Standardized Nuclear Unit
Power Plant System

SLNRC 83-0063 FILE: 0671.1
SUBJ: NUREG-0737, Item I.D.1 "Control
Room Design Reviews"

HUMAN ENGINEERING FINDINGS AND RESPONSES

SNUPPS CONTROL ROOM

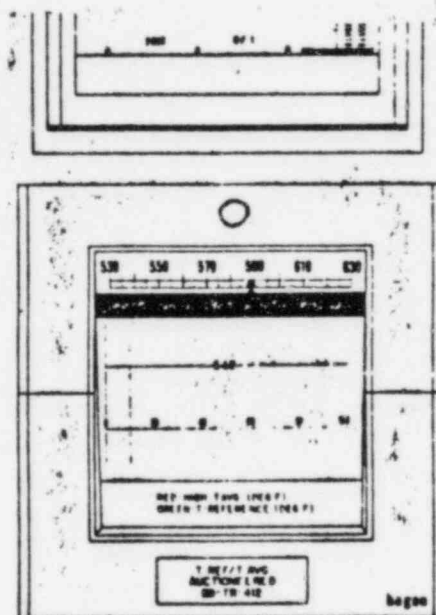
Finding 15 (2) The labels for some indicator lights on RL013, RL014, and RL018 are located below the lights. Labels are conventionally placed above their associated components elsewhere in the control room.

Response On panels RL013 and RL014, the nameplates for some indicator lights are located below the lights in order to provide needed information while maintaining the mimic to a reasonable size. On RL013, pump discharge valve position lights are located at the bottom of the panel and due to the specific arrangement, the identification of these lights is positive and unambiguous. On panel RL014, the 345kV circuit breaker controls consists of time-proven control switches and indicating lights. This arrangement provides the most compact arrangement possible for these devices considering back panel wiring. Operation of these controls is infrequent and does not require rapid component identification. In some cases control switches are only shown by the mimic, these nameplates are also located below the lights for consistency within the switchyard mimic.

Generally, all controls and indicators located on panels RL013 and RL014 are related to systems and equipment which are ancilliary to the main unit operation and do not serve safety related systems. Operation of the controls on these panels is infrequent and requires unhurried responses. Additionally, these panels are located at the left extremity of the control board and will have minor effect to the operation of the other control panels.

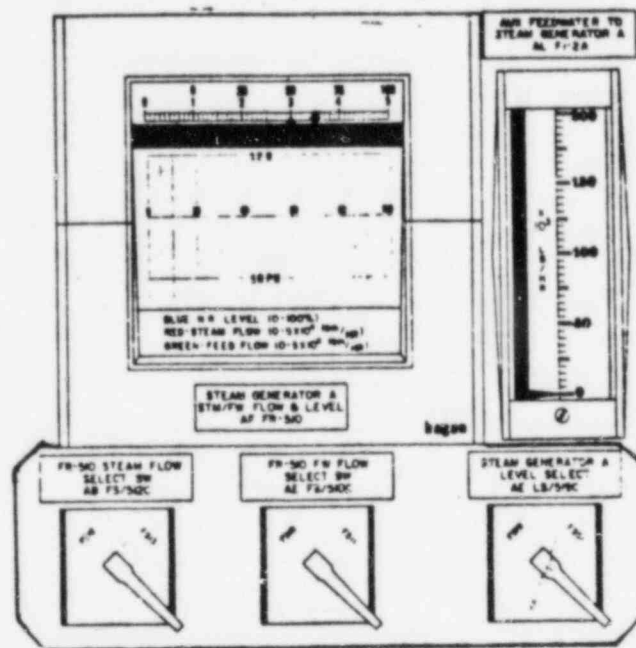
Finding 2 (3) The SAFEGUARD SYSTEMS STATUS SELECT switches on RLO03 are placed between the CRT and the keyboard, but they are not related to the process computer.

Response The Safeguards System Status Select switches will be labeled and demarcated. See 6.05 for a sketch.

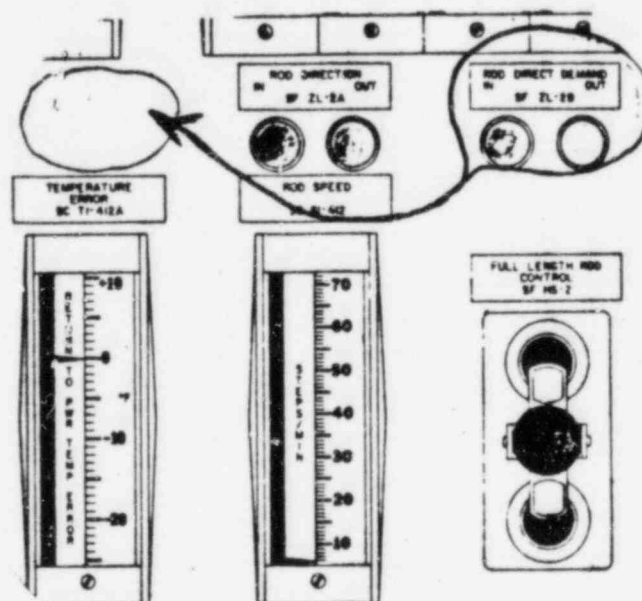
Finding 7 (2) The FUEL POOL COOLING PUMPS B and A controls are located in an inconsistent order with their associated DISCHARGE displays. The displays are correctly ordered A - B, while the controls are ordered B - A.

The ROD DIRECT DEMAND and ROD DIRECTION indicator lights on RL003 are also located in inconsistent order with their associated controls.

Response The Fuel Pool Cooling Pump controls and the Fuel Pool Heat Exchanger CCW Discharge Isolation Valve controls

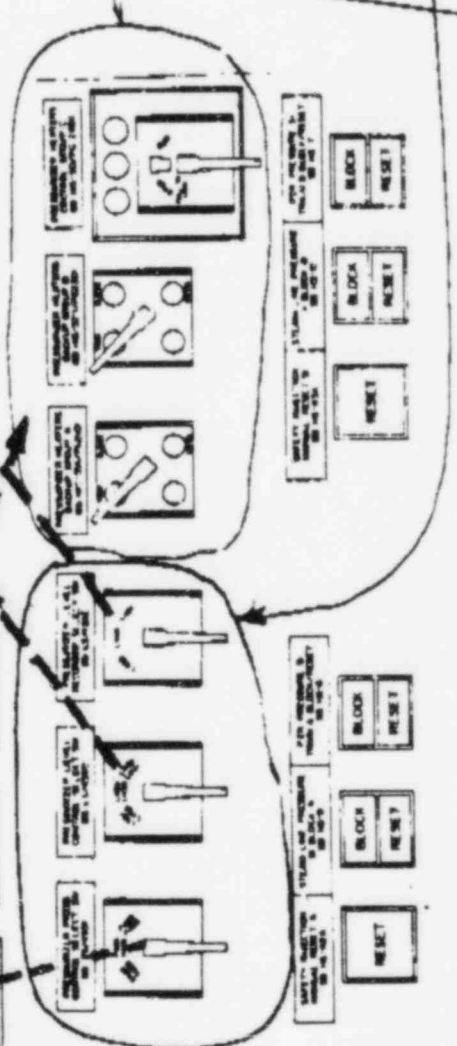
Finding 13 (2) The control groups in the CVCS mimic are in reversed orientation from their associated displays. The LET-DOWN HX OUTLET control is located on the left half of RL001. The LETDOWN HX OUTLET display is located on the right half of RL002. The BORIC ACID TO VCT controls are located on the right half of RL001. The BORIC ACID TO VCT display is located on the left half of RL002.

Finding 14 (2) Three PRESSURIZER HEATER controls and three PRESSURIZER PRESSURE and LEVEL controls are reversed with respect to their associated displays.

Response The Letdown HX Outlet display is located towards the center of RL002. Pressurizer controls and displays are on the right half of RL002. The existing arrangement places the key displays and controls concerning pressurizer level, and pressure immediately adjacent to the reactivity controls and indications where one person can readily monitor the major reactor system parameters. The controls and indication on RL002 for boric acid constitute a stand alone control station for boration and dilution. The controls on RL001 would be used manually only if those on RL002 malfunction. Automatic controls are located on RL002. The operator has the option of selecting either "manual" or "automatic" functions. Boration and dilution are not fast response actions.

Response The current arrangement is considered to be adequate as described below:

Attachment to Finding 1.1

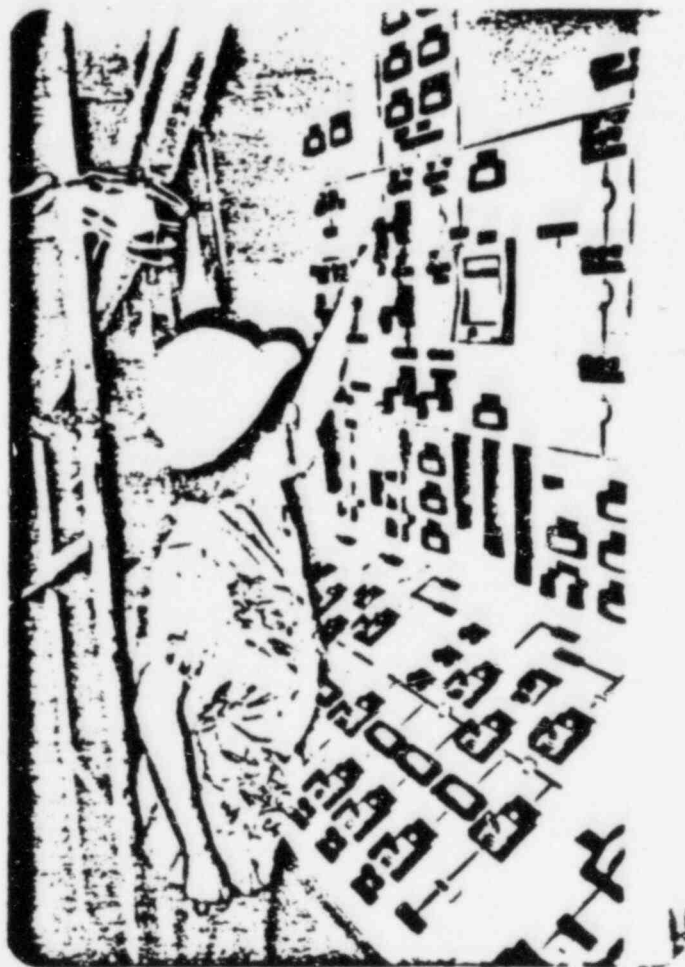
Finding 1 (1) Some controls are located too high to be accessible to a 5th percentile operator. One J-handle switch is located 73" above the floor. Some emergency controls for the BORON INJ RECIRC PUMP are located 66" above the floor. The maximum recommended height for controls is 56".

Response On panel RL014 at Callaway, the switchyard breaker control switches are located above the recommended height in order to retain their proper relationship to the switchyard mimic which is arranged to show the correct association of the transmission lines, busses and circuit breakers. Manual operation of these control switches is infrequent and is performed only after discussion with and at the direction of the Union Electric system dispatcher so that the operator action is deliberate and unhurried. These control switches can be operated by a 5th percentile operator as the attached picture illustrates.

The referenced control (Boron Inj. Recirc. Pump) which is in panel RL017 is not an emergency control. With its present location (66" above the floor) a 5th percentile operator can perform any necessary functions required as the attached picture illustrates.
